FARRAGUT MUNICIPAL PLANNING COMMISSION

AGENDA

August 17, 2023

SUBJECT: Discussion and public hearing on a site plan for a grocery store and shops for a portion of Parcel 32 and Parcels 33, 72-74, and 76, Tax Map 151, northwest intersection of N. Watt Road and Kingston Pike, Zoned C-1, 10.3 Acres (Schaad Companies, Applicant)

Site Layout Plan

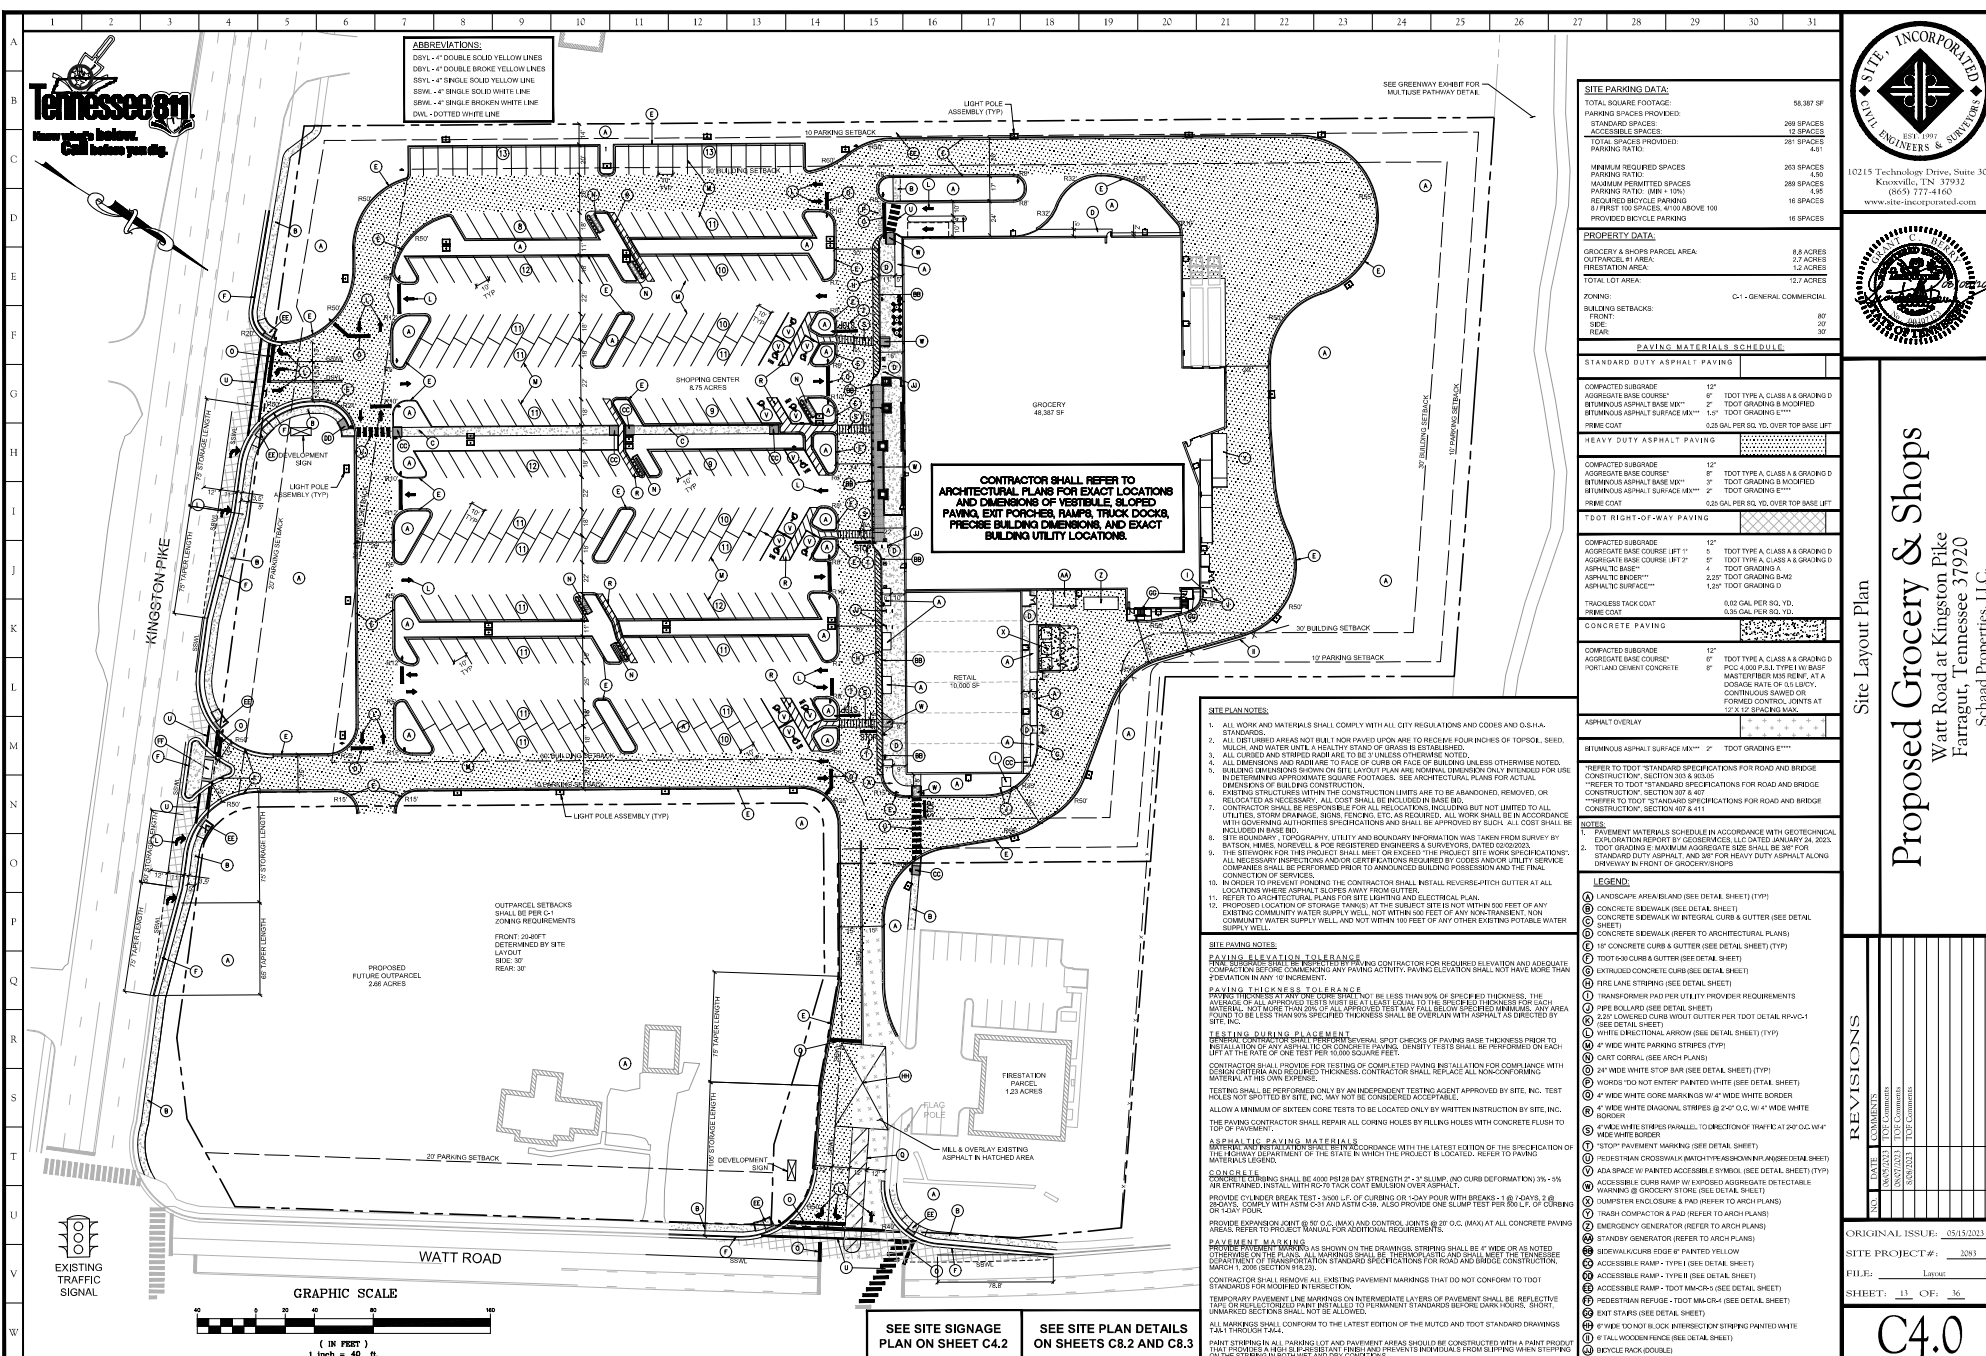
DISCUSSION: During the workshop session, the Planning Commission provided feedback on the general layout of the development, proposed accesses to Kingston Pike, and pedestrian and vehicular accesses to adjoining properties. As shown on the site plan included in the packet, the site includes a roughly 48,000 square foot grocery store and a 10,000 square foot retail building attached to the grocery store. Parking is proposed in the area between the building and Kingston Pike. An outparcel at the intersection of N. Watt Road and Kingston Pike will have vehicular and pedestrian access to the remainder of the development. The Planning Commission was generally satisfied with the overall layout.

Staff noted that the applicant was proposing two access points along Kingston Pike. The eastern access would be a right in/right out and would be roughly 270 feet from the Watt Road intersection. The western access is a full access that will line up with the access to the Y-12 Federal Credit Union and the Kingston Pike Village PCD project on the south side of Kingston Pike. The western access is roughly 200 feet from the right in/right out access proposed to the east. The western access is roughly 170 feet from the access now being used by the Ag-Pro business.

Since Kingston Pike is classified as a major arterial, the new accesses are required to be at least 400 feet apart. Consequently, as proposed, staff indicated that the applicant would have to request a variance from the distance between driveways and distance from intersection requirements in the Driveways and Other Access Ways Ordinance. The applicant is also not proposing a vehicular connection to the property to the west where the Ag Pro is currently leasing the north portion. The Planning Commission expressed support for the proposed accesses along Kingston Pike and didn't express a concern over not including an access to the west, at least where the Ag Pro area is being leased. The variances needed for the Kingston Pike accesses will have to be voted on prior to taking action on the site plan.

The following items were revised on the plans per conversations and TOF comments.

- Outparcel division removed, at this time showing single parcel.
- Topographic survey information shown in grading plans revised per new field information based upon comments.

- TP1.0 plan revised
- C3.0 Pipe materials revised.
- Catch basin on south side of Watt Rd driveway added to extend existing pipe.
- Inlet calculations provided in drainage report for curb inlets A1, A2, and A3. An additional A3A was added to split the drainage area of A3.

- Parking islands relocated to evenly split the parking spaces.
- Islands adjacent to cart corrals modified for width.
- Decel taper from Watt Road added

- OHP line shown on previous plan is existing and is slated for demolition.
- Outdoor seating area shown on sidewalk west of grocery main entrance. Additional seating may be developed along retail space, per area an addition 1100-2600 SF of impervious could be added.

- Markings added at fire station access to caution blocking intersection.
- Fire hydrant relocated.
